REQUEST

Current Zoning: R-MH LWPA LLWPA (residential manufactured housing, Lake Wylie Protected Area, Lower Lake Wylie Protected Area)
Proposed Zoning: I-2(CD) LWPA LLWPA (general industrial, conditional, Lake Wylie Protected Area, Lower Lake Wylie Protected Area)

Approximately 10.918 acres located on the southern side of John Gladden Road, north of Wilkinson Boulevard, and west of Sam Wilson Road

The petition proposes to rezone site to I-2(CD) to develop the site for off-site parking and outdoor storage.

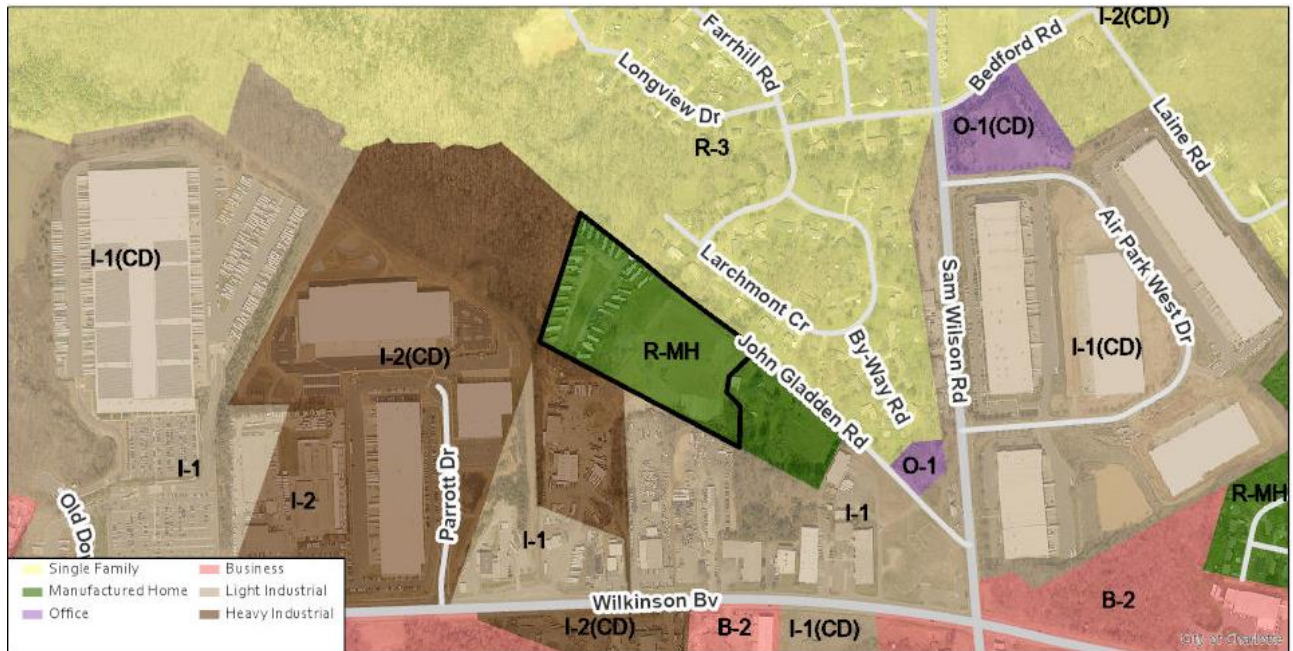
- ~~1. Will need to show required future buffer adjacent to R-3 single family in Development Area A.~~

- ~~2. The petitioner should revise the site plan and conditional notes, in reference to Sections 3.A. and 3.B, to establish and record a cross access easement across Tax Parcel Nos. 053-211-07 and 053-211-10 to Wilkinson Boulevard. Access agreement for all three parcels in the event that one or more parcel(s) is sold to another individual/entity for access to be maintained to Wilkinson.~~

ADDRESSED

ADDRESSED
